Access Compliance Report

Public Rights-of-Way

Intersection ID: 17274	Main Street: MONROE_RD	Cross Street: VISTA_DR	Location: E
ADA ID: D7FF6AF6FC69	Ramp Type: Directional1	Initial Pass/Fail: Pass	Overall Compliance: No
		Severity Score: 0.25

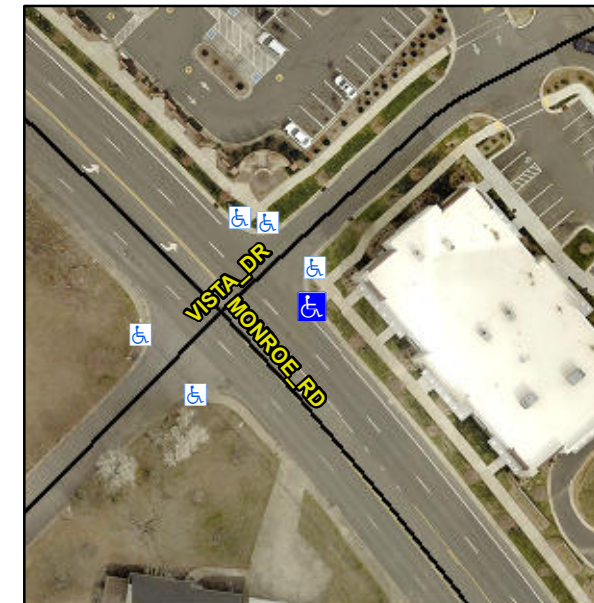
R304.5.3

Compliance	Description	Data	Compliance	Description	Data
N/A	Ramp Length (in)	85.0	Yes	Grade Break?	Yes
Yes	Ramp Width (in)	70.0	Yes	Grade Break Slope (%)	1.6
Yes	Ramp Slope (%)	4.1	Yes	Grade Break XSlope (%)	1.0
No	Ramp XSlope (%)	2.3			
Yes	Flare Type LT	N/A	Yes	Flare Type RT	N/A
N/A	Flare Slope LT (%)	N/A	N/A	Flare Slope RT (%)	N/A
N/A	Flare Traversable LT?	No	N/A	Flare Traversable RT?	No
Yes	Landing Length (in)	70.0	Yes	DWS Provided?	Yes
Yes	Landing Width (in)	70.0	Yes	DWS Contrast?	Yes
Yes	Landing Slope (%)	0.0	Yes	DWS Length (in)	24.0
Yes	Landing X Slope (%)	1.8	Yes	DWS Full Width?	Yes
N/A	Landing Curb? (Y/N)	No	Yes	DWS Offset LT (in)	0.0
N/A	Shared Landing?	No	Yes	DWS Offset RT (in)	8.0
Yes	Gutter Ponding?	No	Yes	Gutter Slope (%)	0.7
Yes	Gutter Lip Ht (in)	0.0	Yes	Gutter X Slope (%)	1.1
N/A	Painted X Walk1?	No		Road Slope (%)	0.6
	X Walk 1 Direction	To SW		Road X Slope (%)	1.3
	X Walk 1 Width (in)	N/A		Clear Space?	Yes

Remove & Replace Entire Ramp.
